**NOTICE OF FINAL
FINDINGS, CONCLUSIONS, AND DECISION
OF THE CITY OF PORTLAND HISTORIC LANDMARKS COMMISSION
ON AN
APPEALED ADMINISTRATIVE DECISION
(Type II Process)**

CASE FILE: LU 14-186226 HR – New Solar Array
LOCATION: 1552 SE Hickory

The applicant proposes a new 216 square foot solar panel array on the roof to be located on the roof of the existing single dwelling. The solar panels are proposed to be mounted parallel to the east-sloping roof. Also proposed is an energy meter located on the east façade toward the rear of the building.

PARTIAL ROOF PLAN - ARRAY #1 DESIGN
SCALE: 1/4" = 1'-0"

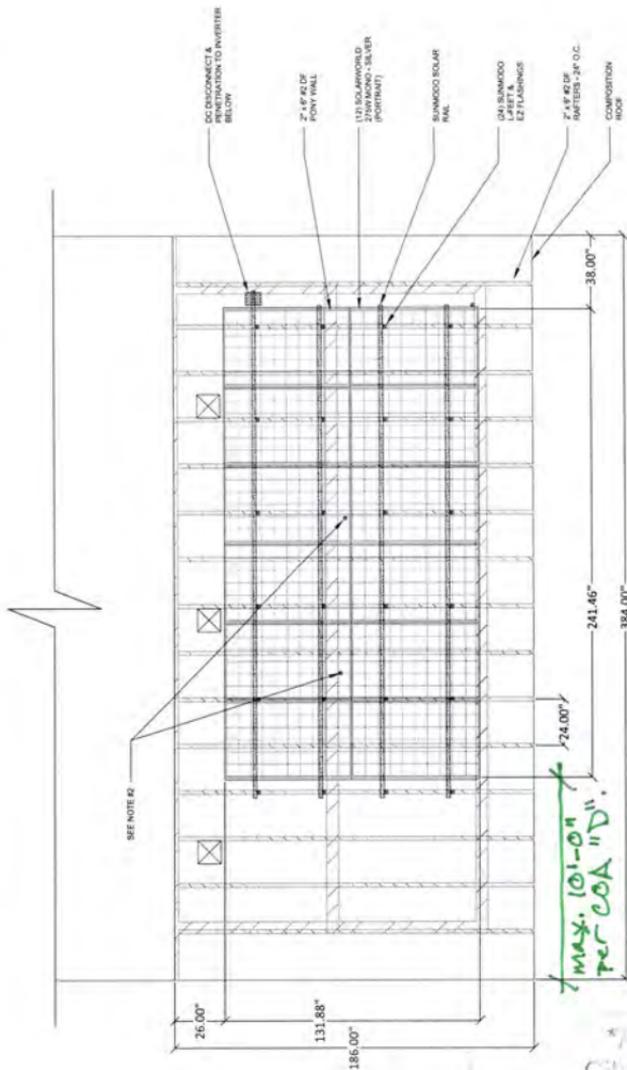
As noted above, the majority of the Commission believed that the proposed array was relatively inconspicuous, due to its location on the rear 2/3 of a single slope of the roof, and suggested conditions of approval to ensure additional inconspicuousness and reinforce aspects of the proposal as presented. These conditions require that the panels be composed of black cells on a black backing, that the array be parallel to the roof slope and be offset no more than 5 inches above the roof as measured from the top of the roof shingles to the top of the panel, that the array be located at least 10 feet back from the front edge of the roof, and that the system be removable.

- A. As part of the building permit application submittal, each of the 4 required site plans and any additional drawings must reflect the information and design approved by this land use review as indicated in Exhibits C-1 through C-7. The sheets on which this information appears must be labeled, "Proposal and design as approved in Case File # LU 14-186266 HR. No field changes allowed."
- B. The solar cells shall be black, on a black background.
- C. The array shall be parallel to the roof slope and offset no more than 5 inches from the top of the roof shingles to the top of the panel.
- D. The array shall be installed at least 10 feet back from the front edge of the roof and the system must be removable.
